寄件者: TsangShun Qi <[REDACTED]>
寄件日期: 2026年04月08日星期三 15:30
收件者: Adrian Tsz Hin TAM/PLAND
主旨: 回复 : Planning Application No. A/NE-TKLN/125 --- Temporary Warehouse for Storage of Electric Cable with Ancillary Open Storage of Construction Materials for a Period of 3 Years
附件: TD proposal 1.pdf; response to TD comment.pdf
類別: Internet Email

A/NE-TKLN-125, Response to comments

Transport Department (TD)

Traffic Impact Proposal

Table 2.4 Current traffic flow in Lin Ma Hang Road (Survey point show in Figure 1.1)

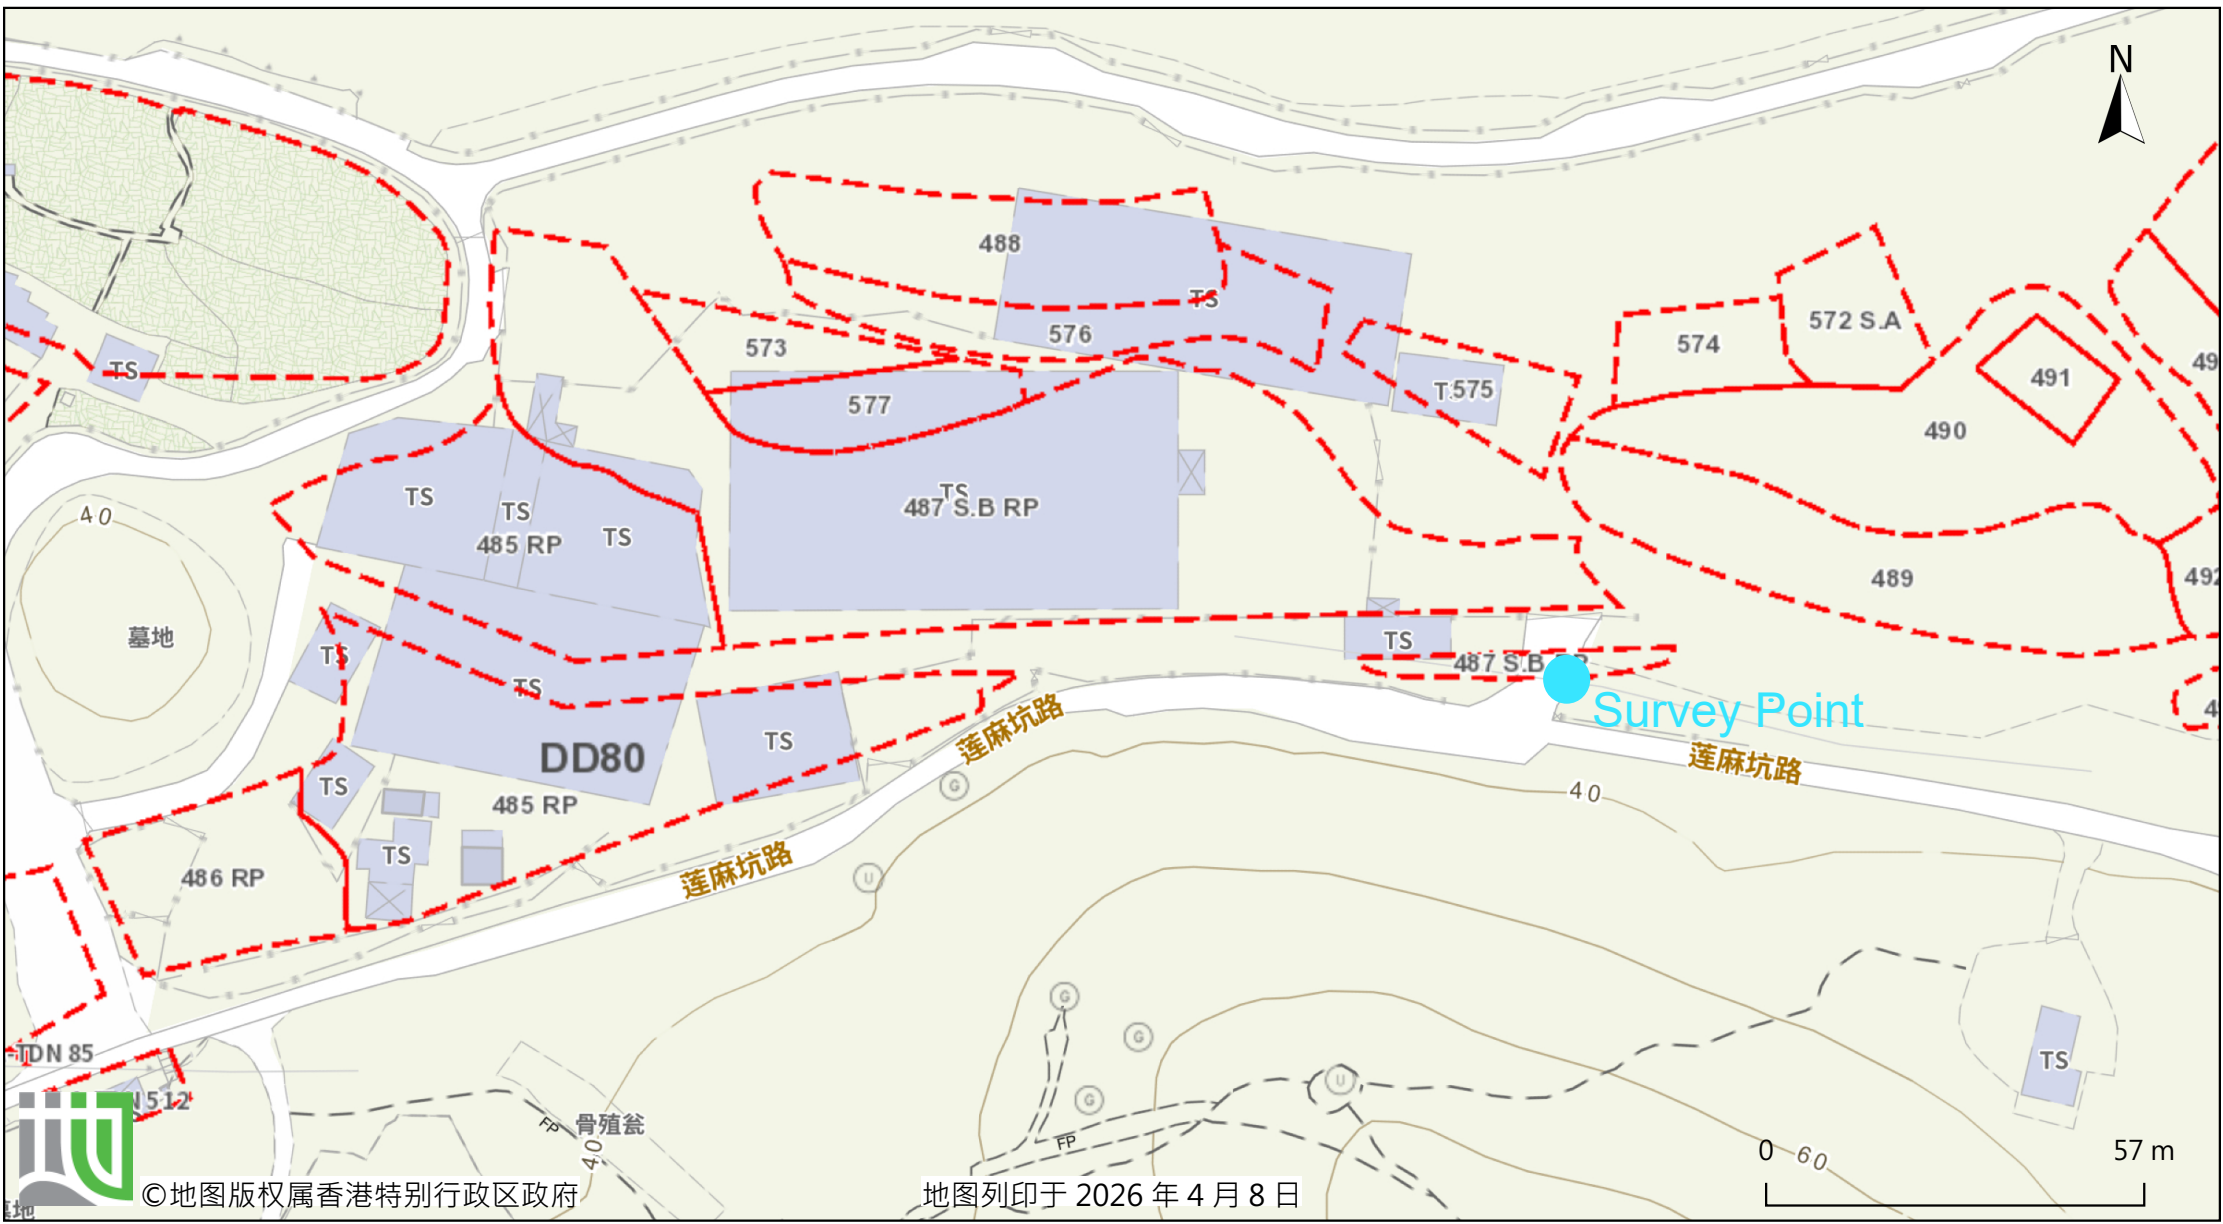
Comment 1
the applicant should advise and substantiate the traffic generation from and attraction to the subject site and the traffic impact to the nearby road links and junctions;
Response
<p>The proposed use of the subject site is for temporary open storage of metal scaffolding with an ancillary office, which is not expected to generate significant traffic. Only two medium goods vehicle (MGV) loading and unloading parking spaces will be provided, which are sufficient to meet the daily operational needs.</p> <p>A traffic impact proposal is provided to estimated traffic generation.</p>

Friday: Total vehicles: 74 (8 hours), average 10 vehicles/hour.

Saturday: Total vehicles: 64 (8 hours), average 8 vehicles/hour. Comparison: Traffic flow on Saturday and Friday (approximately 15%). This is likely due to increased commuter traffic on weekdays.

The additional traffic increase from Dubai development is only about 1 vehicle/hour. No significant traffic congestion, nighttime congestion, or service level decline is expected in the near future. The current situation is unfavorable and will not have any significant adverse impact on the additional traffic volume or service level on Lin Ma Hang Road

Layout Plan

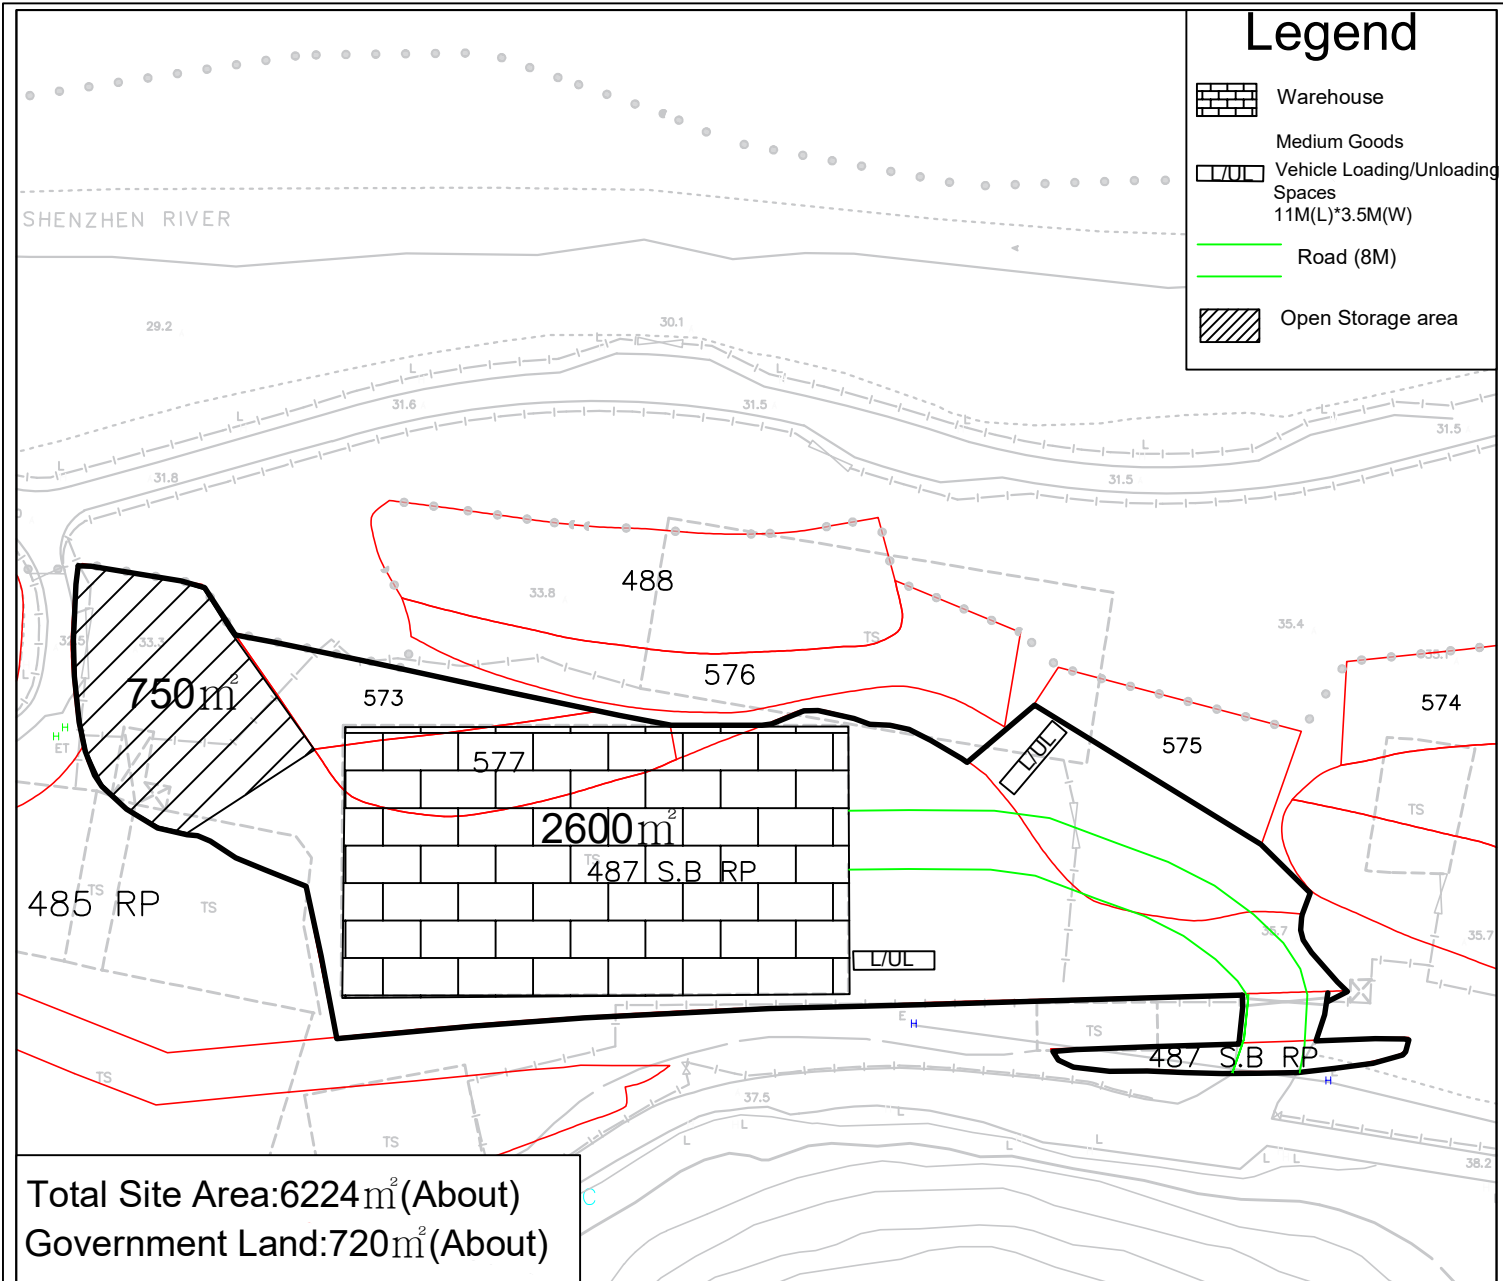
Comment 3
the applicant shall confirm the internal space of the subject site is free from obstruction and the area can be utilised for the parking and maneuvering of vehicles;
Response
<p>The applicant is confirm that the internal space of the subject site is free from obstruction.</p> <p>The swept path plan is provided and demonstrates the sufficient space for the parking and maneuvering of vehicles.</p>

Please find the attached revised Layout Plan. For clarification, the applicant would like to confirm the following:

1. The proposed warehouse is intended for the storage of electric cables, which will be supplied to CLP's contractors.
2. The proposed open storage area is for the storage of construction materials such as iron frames, angle iron, aluminium tubes, and wooden cable reels for electric cables.
